Access Compliance Report

Public Rights-of-Way

(Pedestrian Signals)

Intersection ID: N/A	Main Street:	Cross Street: N/A	Location: N/A
ADA ID: F3CD48064A58	Signal Type: Two Push Buttons-Non APS	Overall Compliance: No	Severity Score: BTN 1:N/A BTN 2: N/A No BTN: N/A
Codes/Mitigation Info/Possible Solution		Field Measurements/Component Compliance

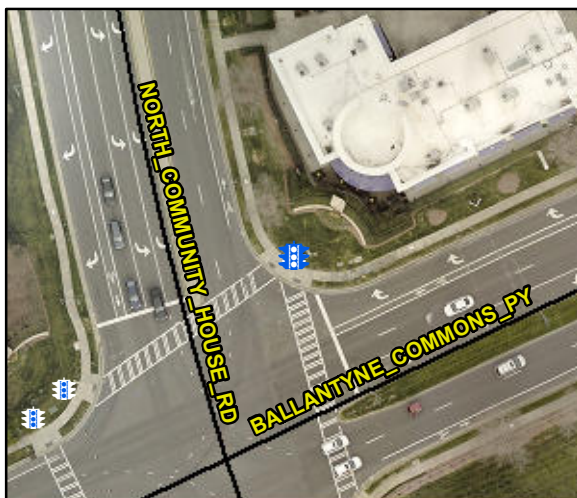
Compliance	Description	Data	Compliance	Description	Data
	Button Count	Button2	N/A	Distant to Additional Button (in)	N/A
	Additional Button Present?	No		Additional Button ID	N/A
N/A	Signal Buttons Required?	N/A	N/A	Additional Ped Posts Required	N/A
	How Many Ped Street Xings?	2		Located In An Island/Median?	No
N/A	B 1 Sign Present?	Yes	N/A	B 2 Sign Present?	Yes
Yes	B 1 Sign Purpose?	Yes	Yes	B 2 Sign Purpose?	Yes
Yes	B 1 Sign Lettering & Contrast?	Yes	Yes	B 2 Sign Lettering & Contrast?	Yes
No	B 1 Parallel To XWalk?	No	Yes	B 2 Parallel To XWalk?	Yes
Yes	B 1 PAR to Button?	Yes	Yes	B 2 PAR to Button?	Yes
Yes	B 1 PAR to XWalk?	Yes	Yes	B 2 PAR to XWalk?	Yes
Yes	B 1 Clear Floor Space?	Yes	Yes	B 2 Clear Floor Space?	Yes
N/A	B 1 FWD Approach?	Yes	N/A	B 2 FWD Approach?	Yes
N/A	B 1 FWD Approach Constrained?	No	N/A	B 2 FWD Approach Constrained?	No
No	B 1 FWD Approach Reach (in)	7.0	No	B 2 FWD Approach Reach (in)	7.0

N/A	B 1 FWD Approach Width (in)	N/A	N/A	B 2 FWD Approach Width (in)	N/A
N/A	B 1 FWD Approach Obstruction?	Yes	N/A	B 2 FWD Approach Obstruction?	Yes
N/A	B 1 FWD Approach Obstruction Dist (in)	7.0	N/A	B 2 FWD Approach ObstructionDist (in)	7.0
N/A	B 1 PARA Approach?	Yes	N/A	B 2 PARA Approach?	Yes
N/A	B 1 PARA Approach Constrained?	No	N/A	B 2 PARA Approach Constrained?	No
Yes	B 1 PARA Approach Reach (in)	7.0	Yes	B 2 PARA Approach Reach (in)	7.0
N/A	B 1 PARA Approach Width (in)	N/A	N/A	B 2 PARA Approach Width (in)	N/A
N/A	B 1 PARA Approach Obstruction?	Yes	N/A	B 2 PARA Approach Obstruction?	Yes
N/A	B 1 PARA Approach Obstruction Dist (in)	7.0	N/A	B 2 PARA Approach ObstructionDist (in)	7.0
Yes	B 1 Clear Floor Space Slope (%)	1.4	Yes	B 2 Clear Floor Space Slope (%)	2.3
Yes	B 1 Clear Floor Space XSlope (%)	0.3	No	B 2 Clear Floor Space XSlope (%)	6.4
N/A	B 1 PAR Slope (%)	1.4	N/A	B 2 PAR Slope (%)	2.3
Yes	B 1 Height (in)	36.0	Yes	B 2 Height (in)	36.0

Yes	B 1 Clear Xing Direction?	ClearlyMarked	Yes	B 2 Clear Xing Direction?	ClearlyMarked
	B 1 Crossing Direction	To SW		B 2 Crossing Direction	To SE
Yes	B 1 DistanceTo XWalk (in)	0.0	Yes	B 2 DistanceTo XWalk (in)	0.0
No	B 1 DistanceTo Curb (in)	117.0	No	B 2 DistanceTo Curb (in)	129.0
Yes	B 1 Diameter (in)	2.0	Yes	B 2 Diameter (in)	2.0

Possible Solutions: Replace Signal Push Button With APS Button on New Post. Remove & Relocate Sign.
